**6572A-05A**

**S E R V I C E N O T E**

**6572A DC POWER SUPPLY MANUALLY CONTROLLED**

**The Current Shunt (Circuit Reference “R407” may have intermittent sense wires, which may cause Instability of Current regulation, Current read back and Current programming.**

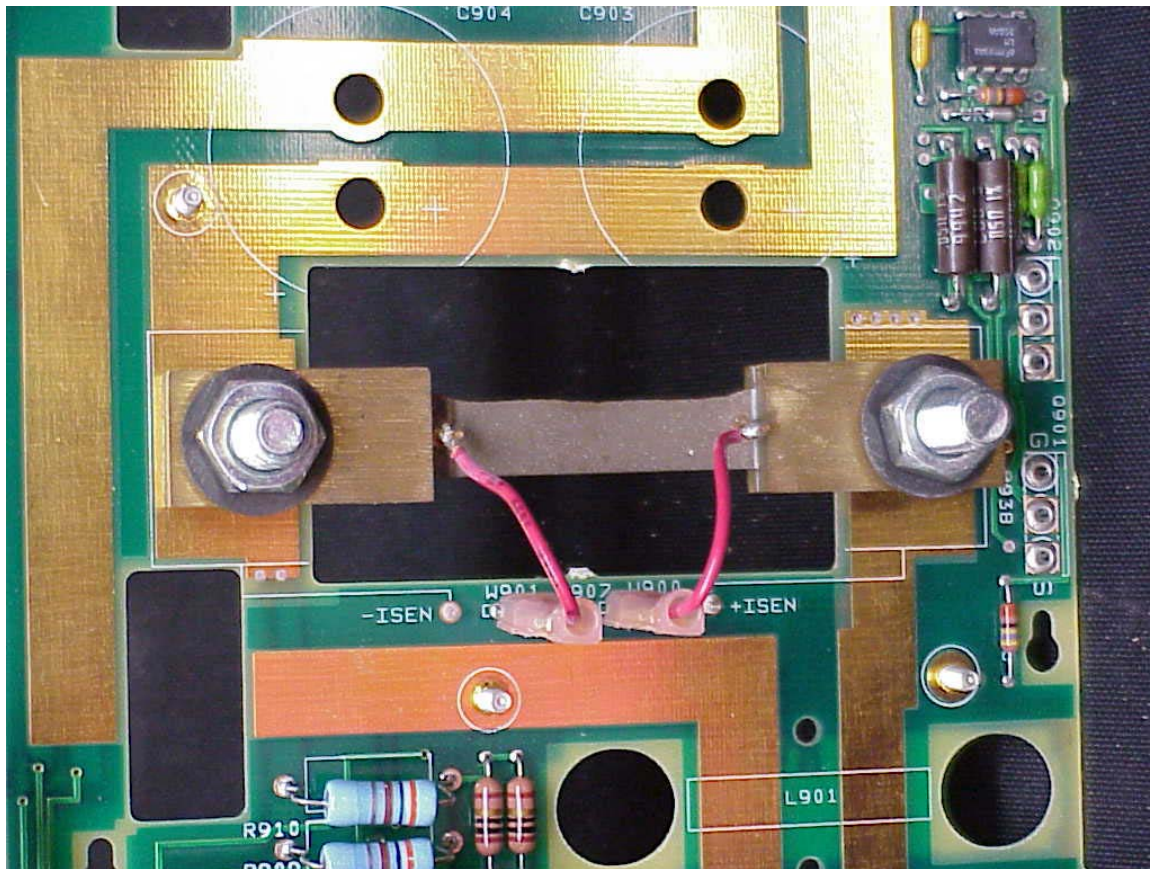
This picture shows how the Shunt R907 is connected using the term-crimp connectors.

The Shunt R907 is connected to "W900" & "W901"

Cut the terminal-crimp connectors off of both wires and discard the connectors. Make this cut as close to the terminal-crimp connector as possible. The required strip length should be 5mm. This strip length will be used to prevent the wire length being too long and shorting to the instrument chassis. If replacement of this wire is required any color (22 AWG, 300V 105C) wire type can be used.

This modification can be done from the top of the board. Carefully strip and solder the wires, and avoid burning the wire insulation and the printed circuit board.

The wires should be connected as shown below. The two holes marked -ISEN & +ISEN should be used. Do not cross the wires when making this modification. See picture below for details. This picture shows the required modification.
